GEOTECHNICAL AND GEOLOGIC HAZARD INVESTIGATION
The Ridge Nests Development
Powder Mountain Resort
Weber and Cache Counties, Utah

IGES Project No. 01628-008

Subject: Response to Review Comments
Geotechnical Investigation
The Ridge Nests Development
Powder Mountain Resort
Weber and Cache Counties, Utah

Subject: Response to Review Comments - Geology
Geotechnical Investigation
The Ridge Nests Development
Powder Mountain Resort
Weber and Cache Counties, Utah

C:\DOCUME~1\DAVIDG\DESKTOP\01628008\B1.PL2 Run By: DAG 9/1/2015 2:04PM

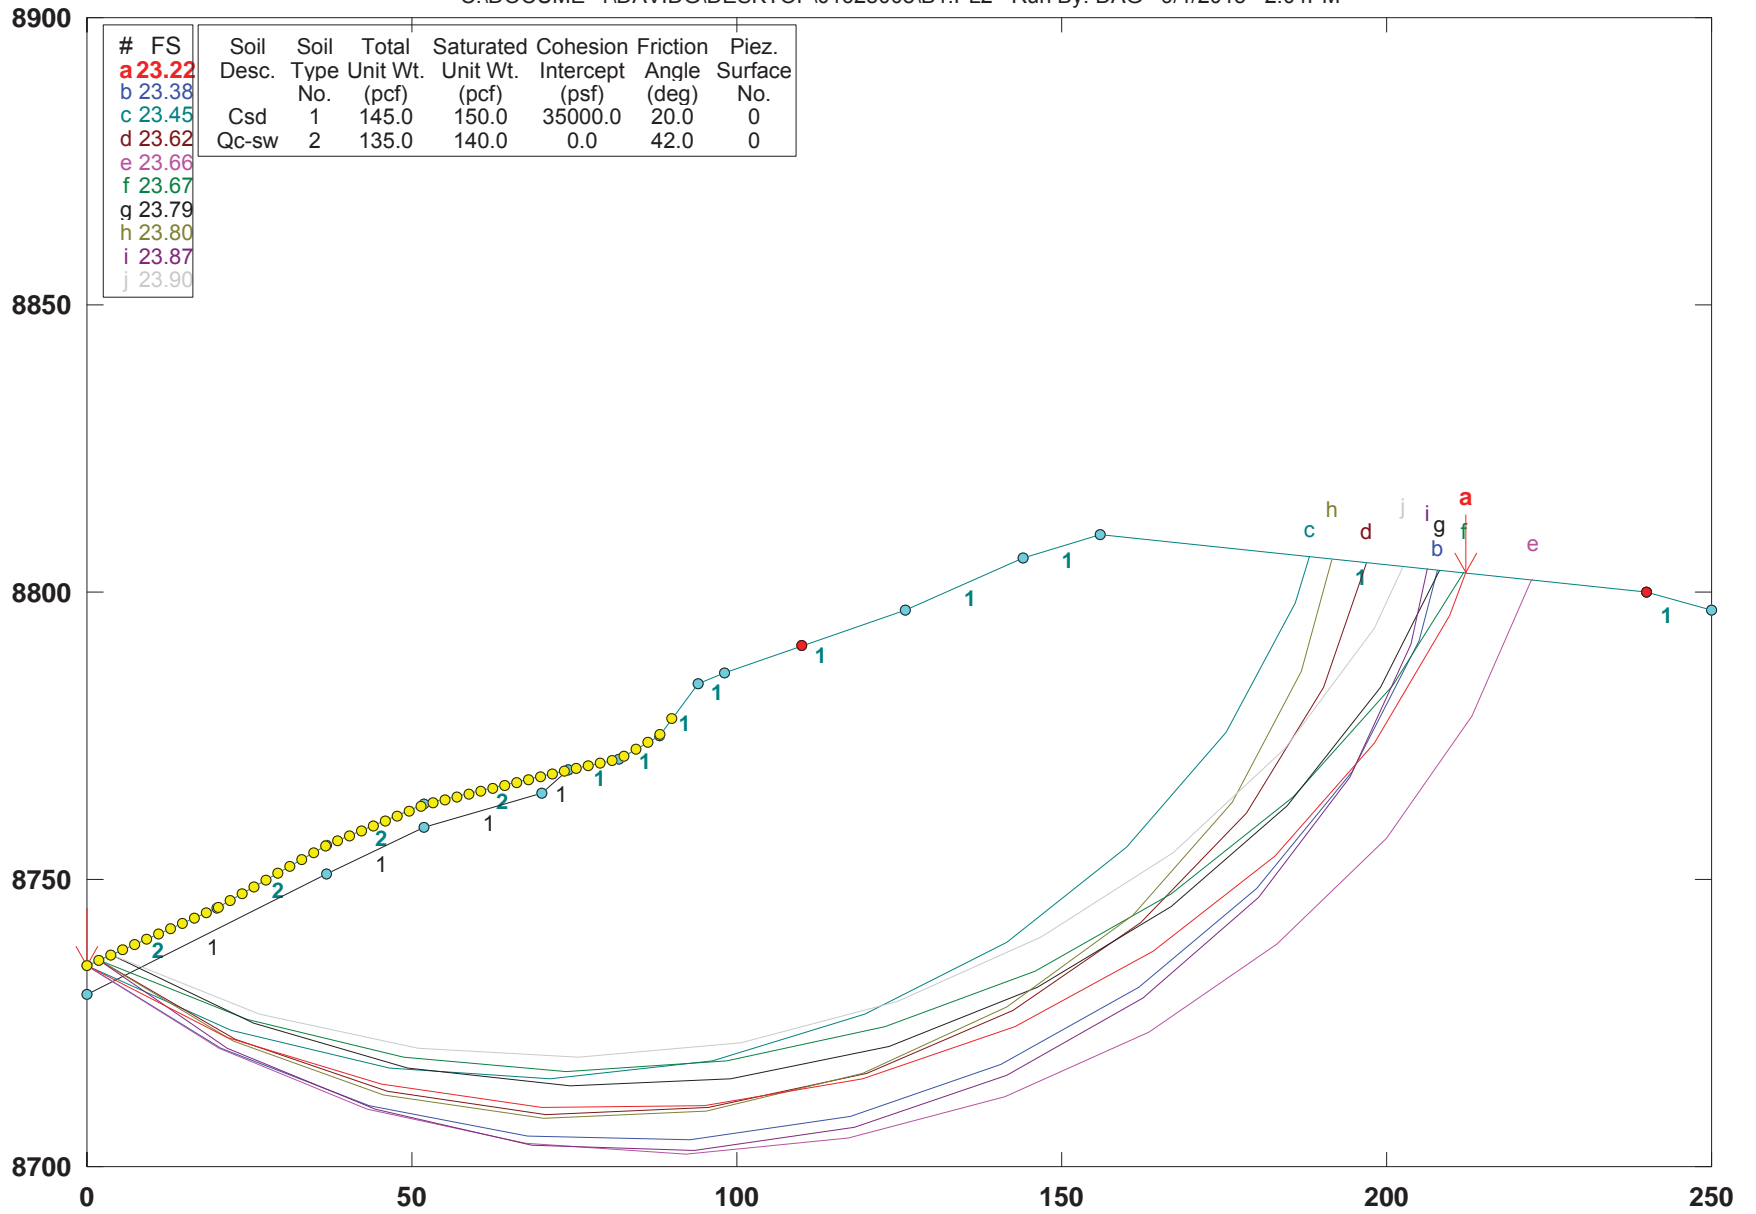
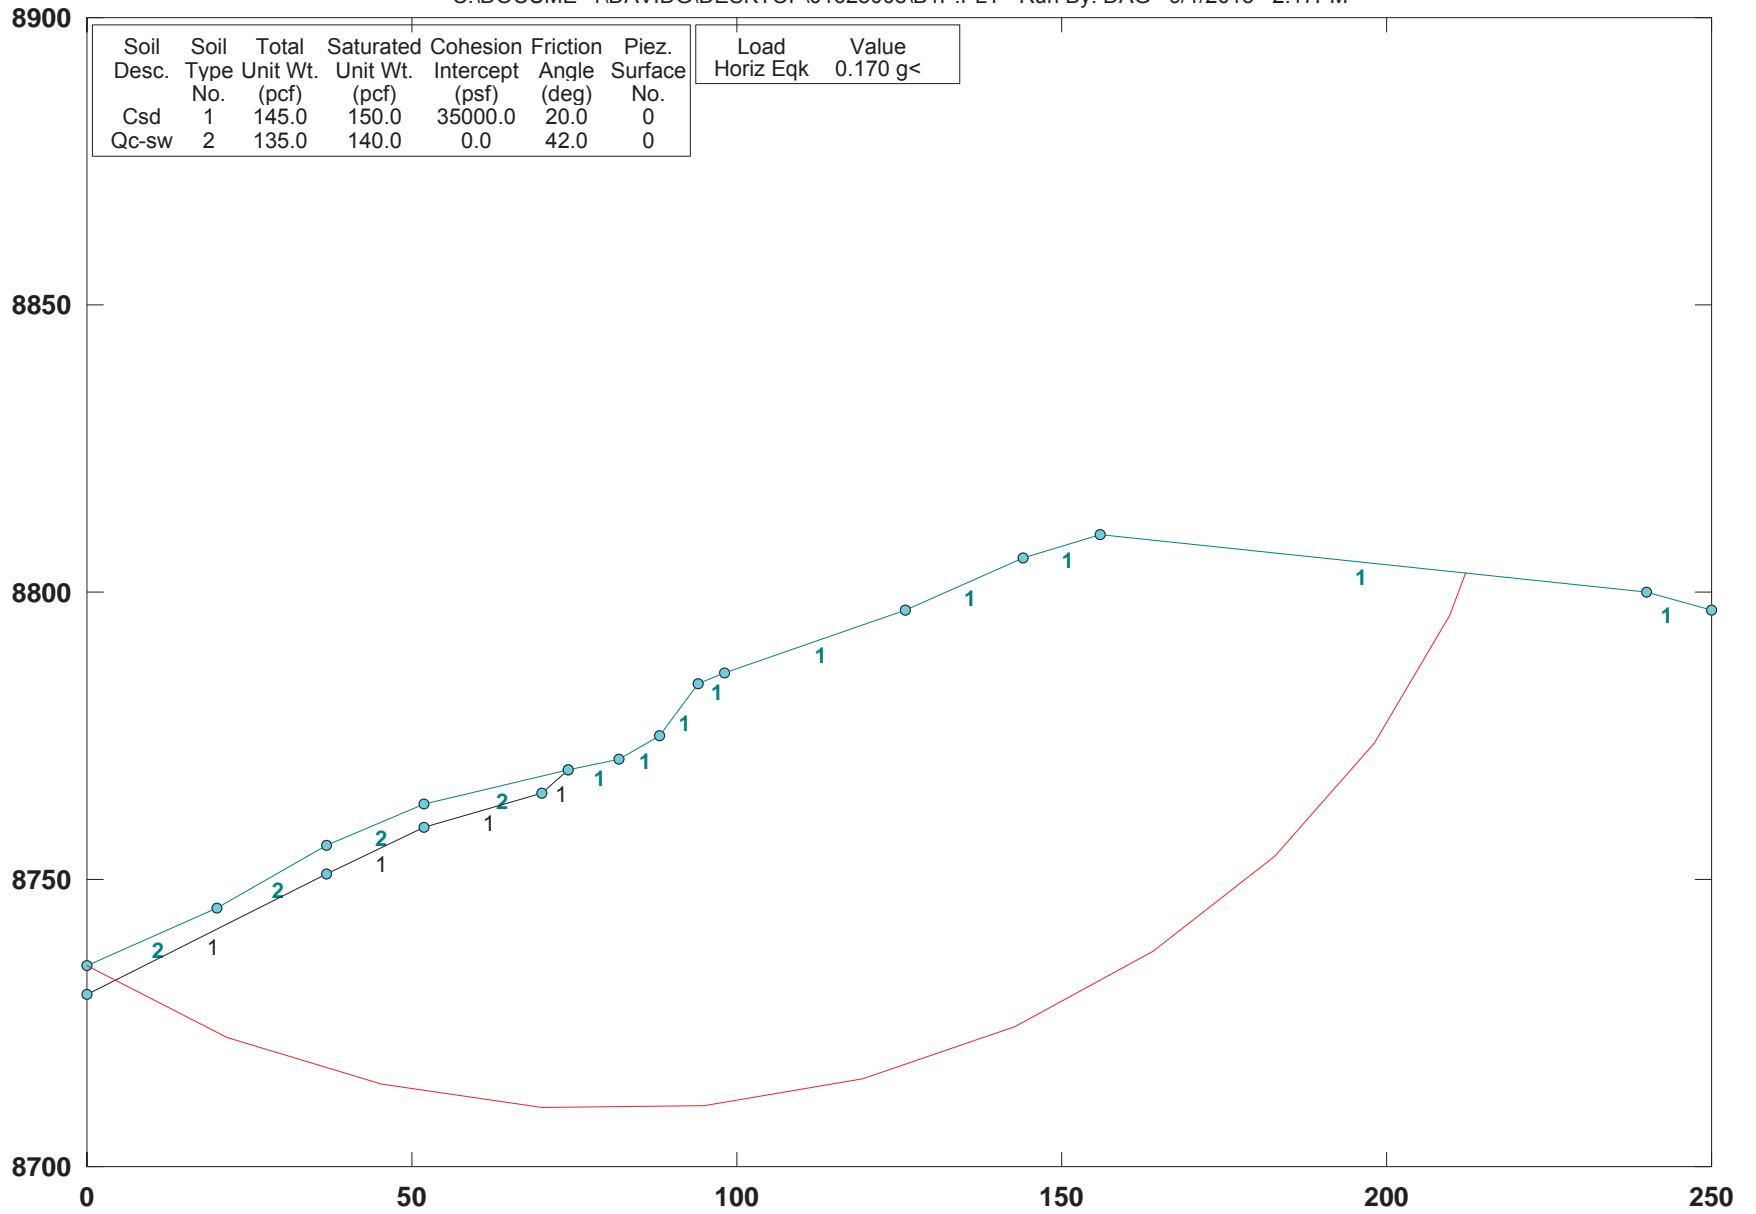
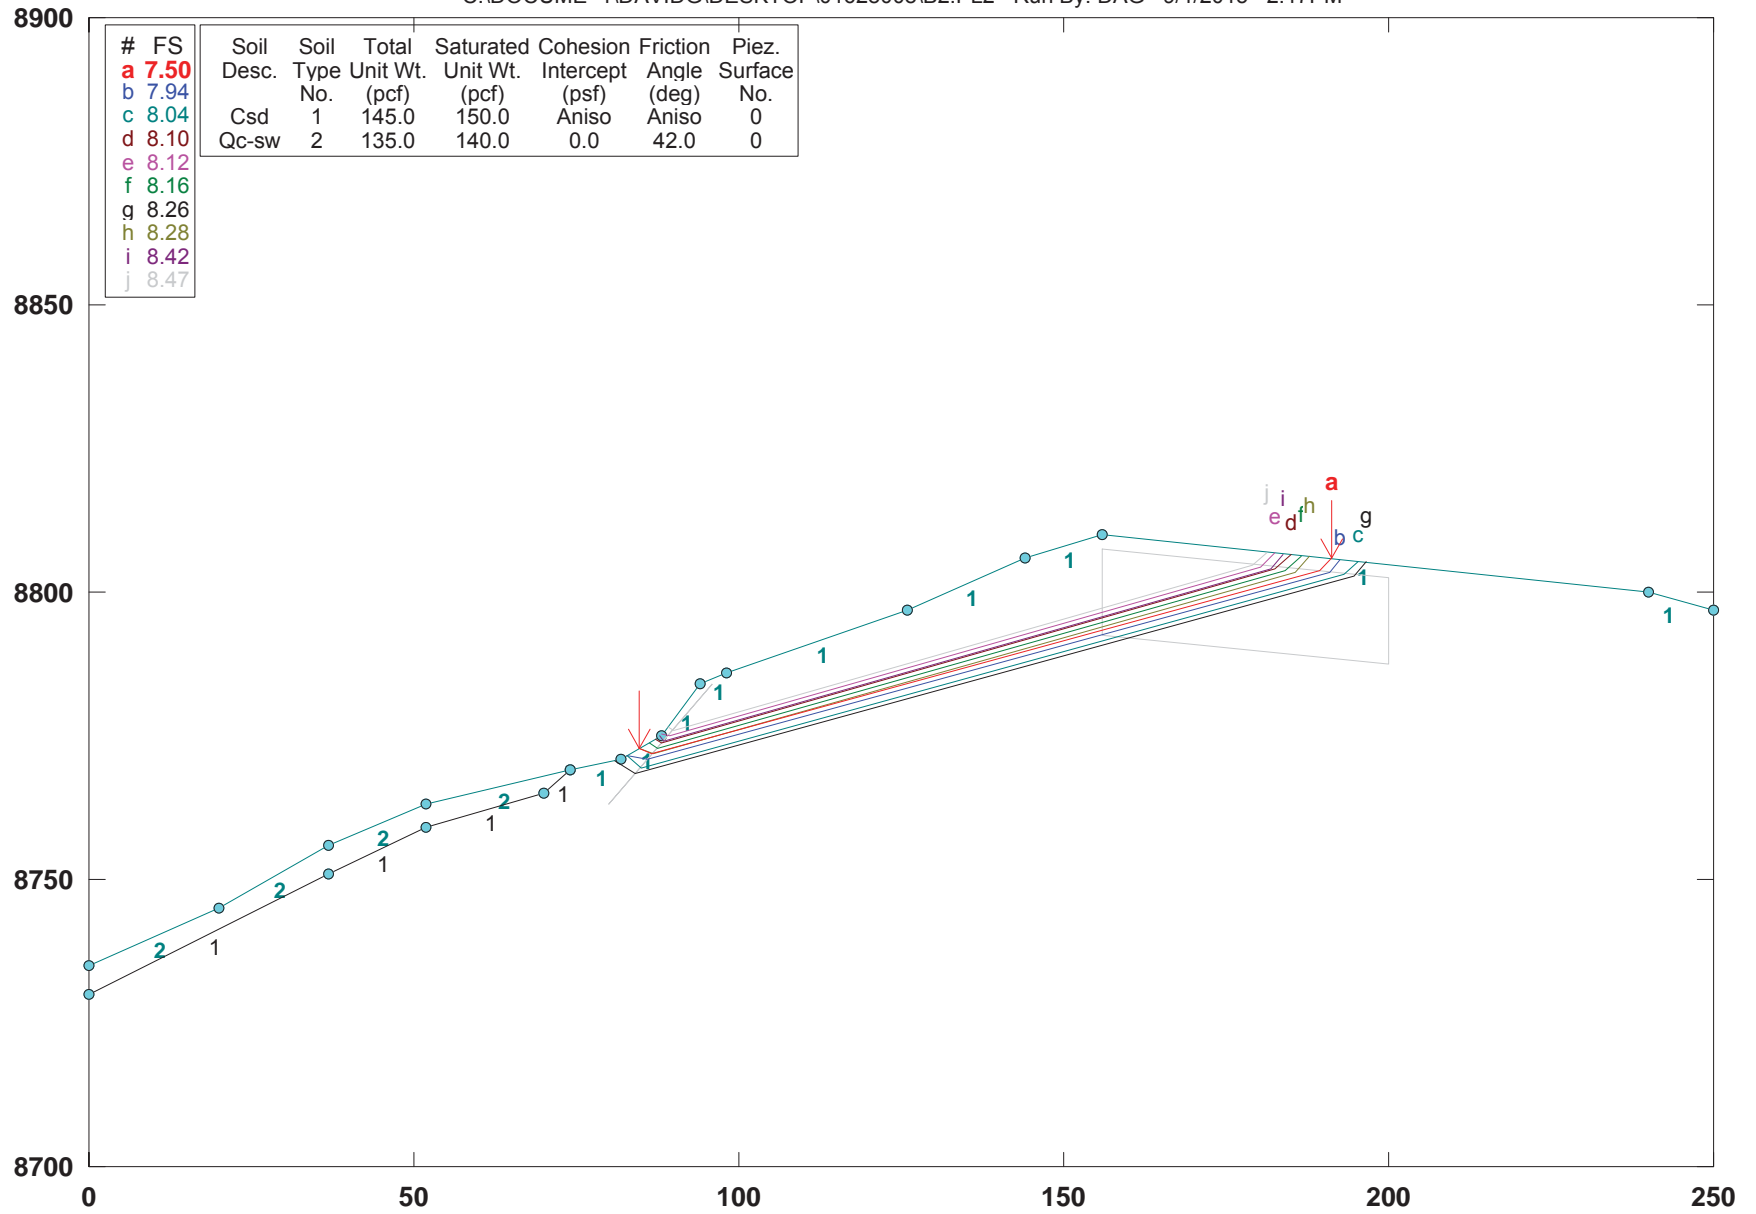
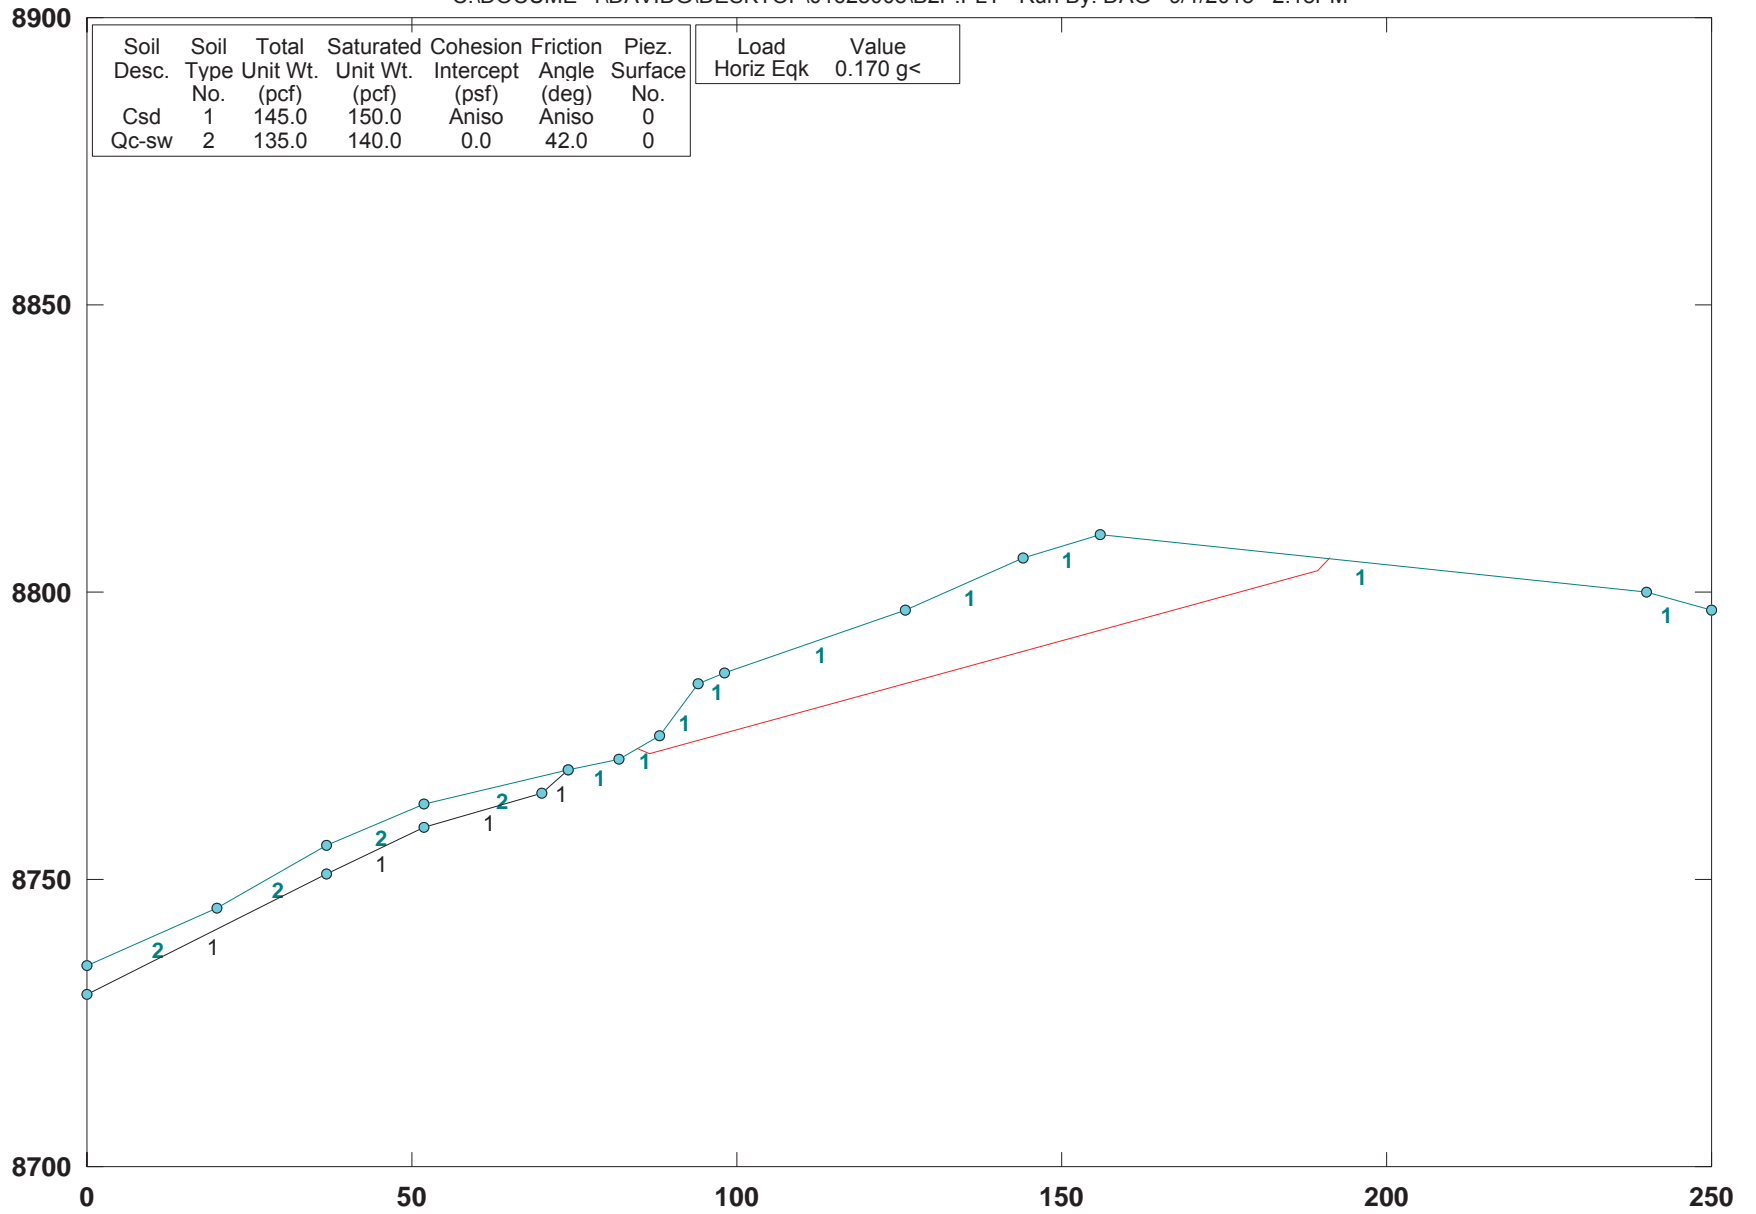
“The September 23, 2015, IGES response letter did not describe the properties of the bedding and/or jointing for incorporation into the slope stability analyses, e.g., properties such as, strike and dip, degree of fracturing (generally controlled by the number of joints in a given direction), persistence of jointing, spacing of jointing, roughness of joint surface, open and/or closed joints, joint coatings and infillings, etc.

The global stability of the slope was modeled using gSTABL7 slope stability software. Bishop’s Method and Janbu’s Simplified method was used to model the slope, as appropriate. For our analysis, we have assessed two representative sections, Section A-A’ and Section B-B’, illustrated on Plate 1 (*Geologic Map*) and the *Geologic Cross-Sections*, Figure 1, attached. Calculations for stability were developed by searching for the minimum factor-of-safety for both a circular-type failure and a block-type (translational) failure. For the circular analysis model, arcuate failure surfaces and homogenous earth materials were assumed. For the block analysis, anisotropic strength parameters in the bedrock was assumed, based on the apparent dip of bedding. A minimum static factor-of-safety of 1.5 and seismic factor-of-safety of 1.0 (global stability) was considered acceptable for this project considering the available information and design assumptions.
